ADC Telecommunications				REV	ECO	DATE	APV	
APV	THIS PRINT IS THE PROPERTY OF ITS CORP IT SHALL NOT BE COPIED WITHOUT PERMISSION			TITLE				
DATE				SCH., ANALOG MODULATOR BD, SYSTEM M/N.				
	MATERIAL							
				DWN	PJK	2/7/98	DWG. NO.	REV
ECO				1585-3305				2
	FINISH			CHK	DWB	2/9/98		
REV				REL	DWB	2/9/98	D	SCALE - - - SHEET 1 OF 2

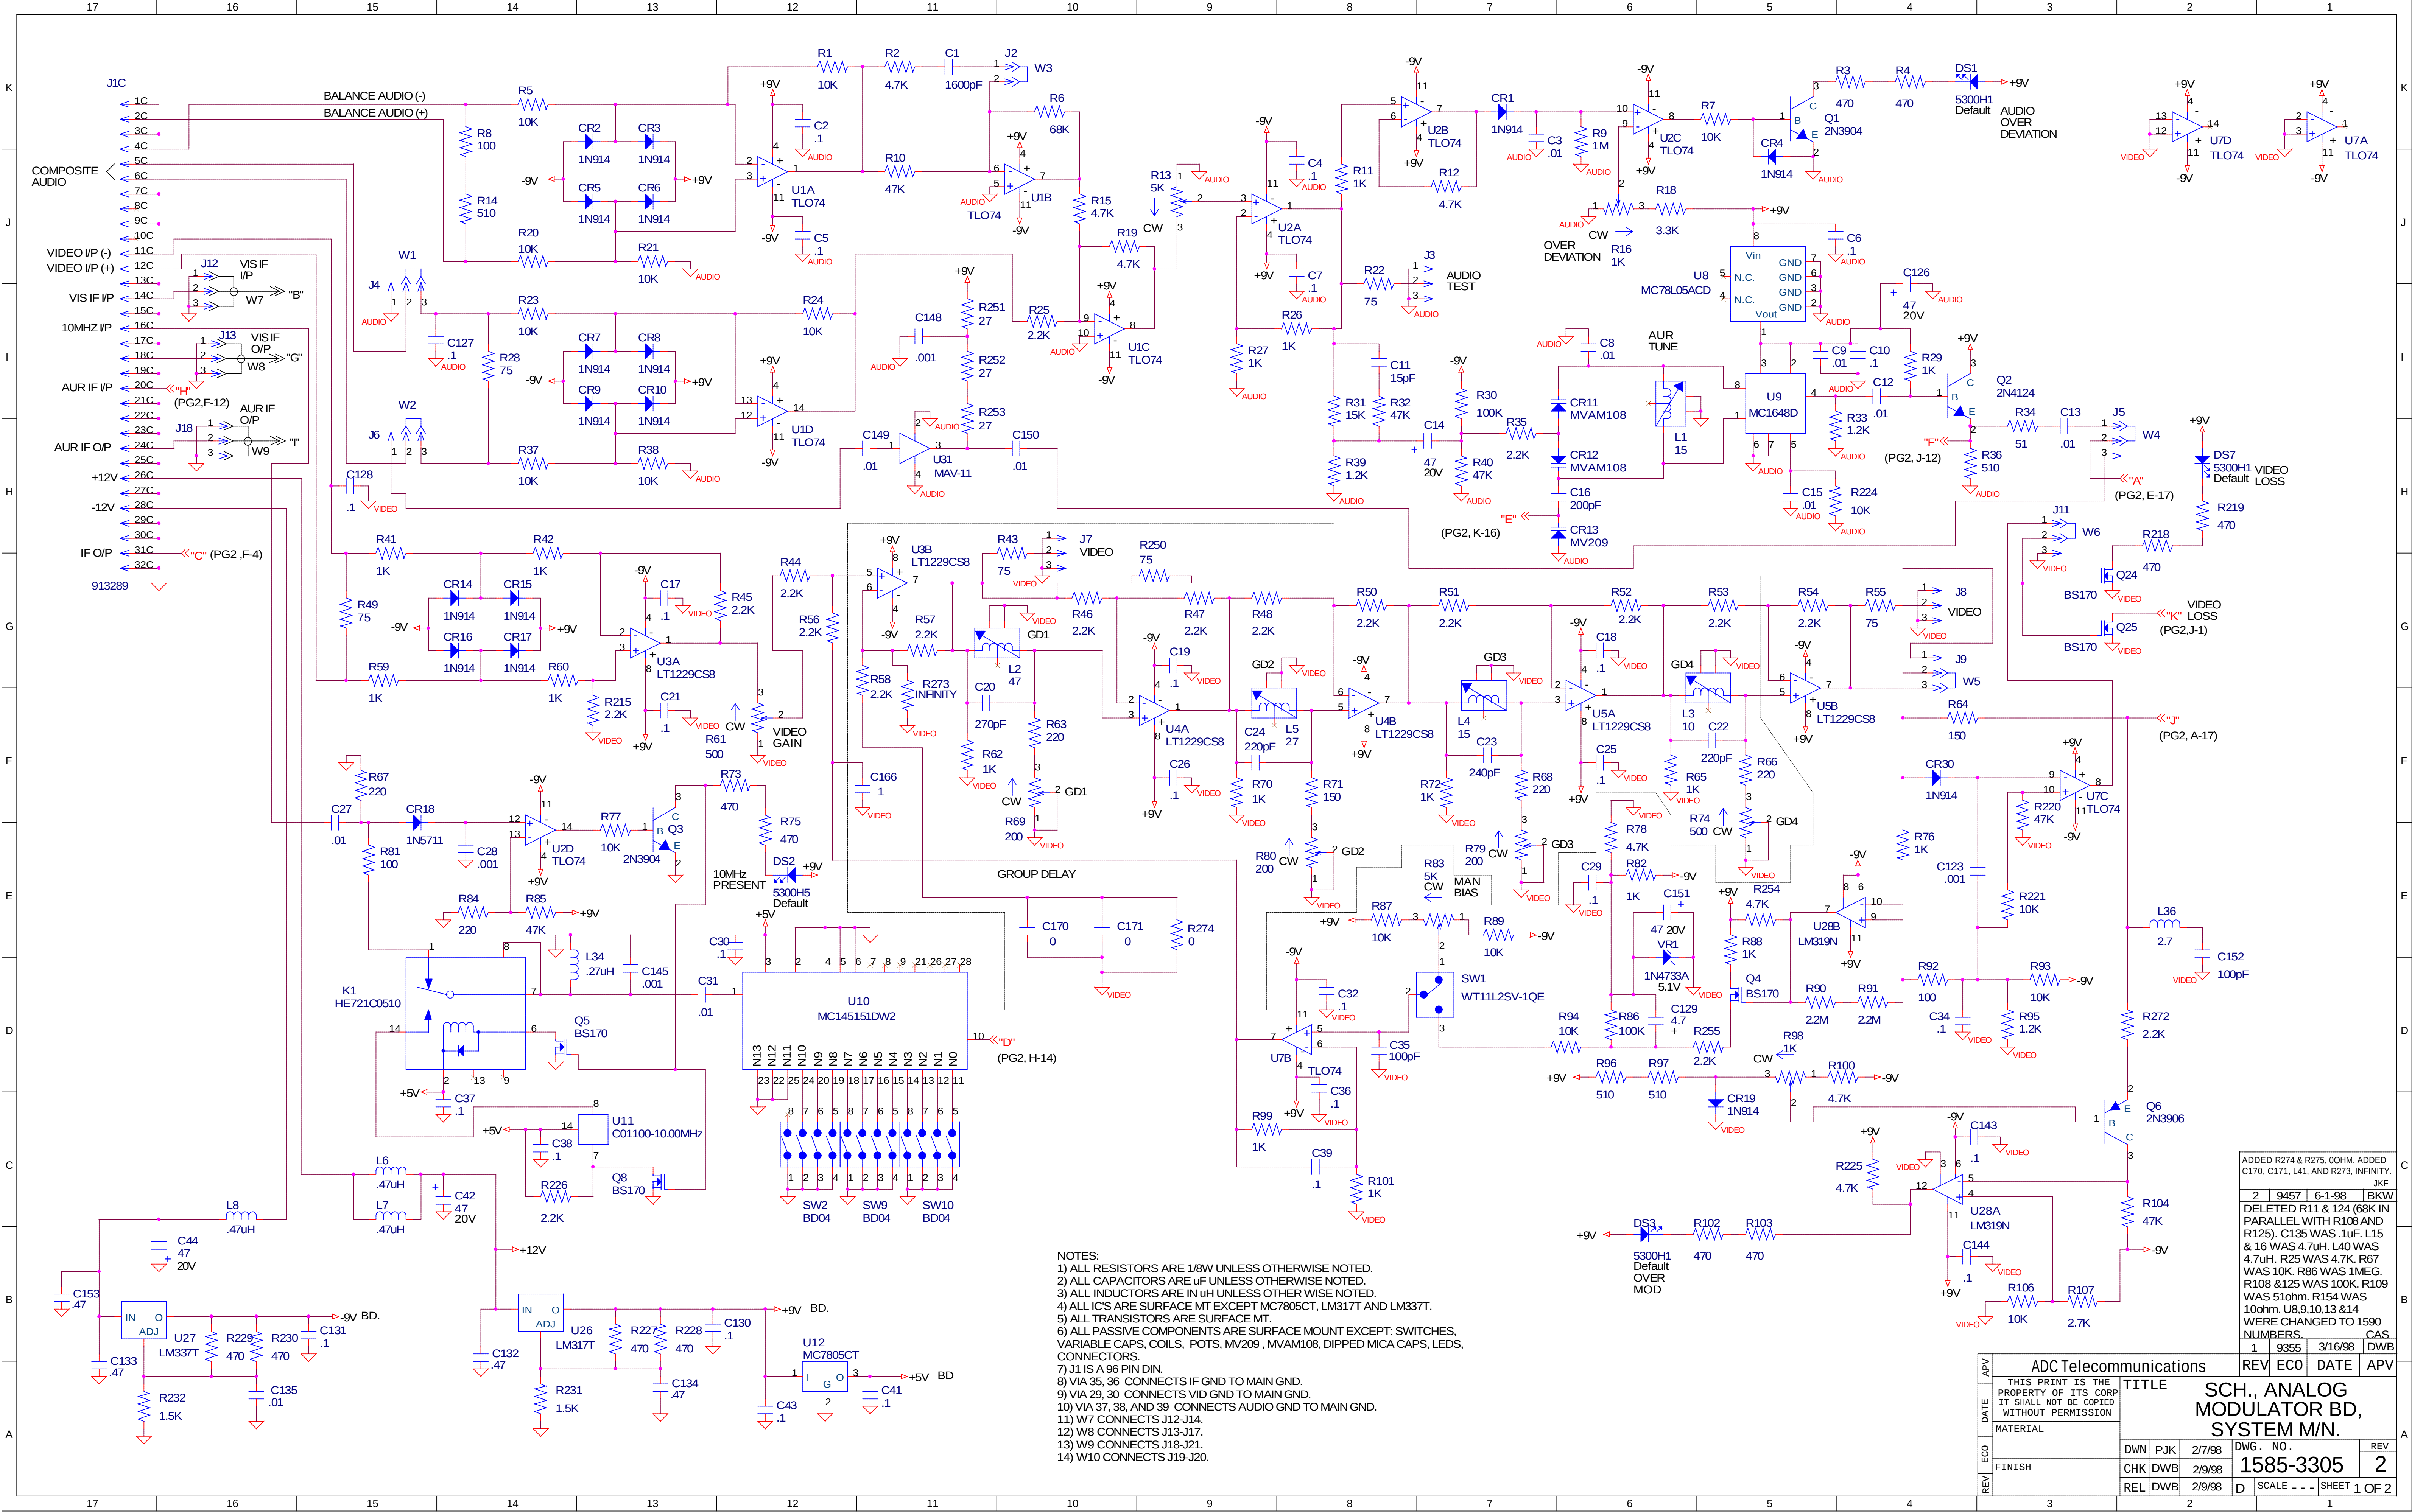
ADDED R274 & R275, 00HM. ADDED C170, C171, L41, AND R273, INFINITY. JKF

2	9457	6-1-98	BKW
DELETED R11 & 124 (68K IN PARALLEL WITH R108 AND R125). C135 WAS .1uF. L15 & 16 WAS 4.7uH. L40 WAS 4.7uH. R25 WAS 4.7K. R67 WAS 10K. R86 WAS 1MEG. R108 & 125 WAS 100K. R109 WAS 51ohm. R154 WAS 10ohm. U8,9,10,13 & 14 WERE CHANGED TO 1590 NUMBERS. CAS			
1	9355	3/16/98	DWB
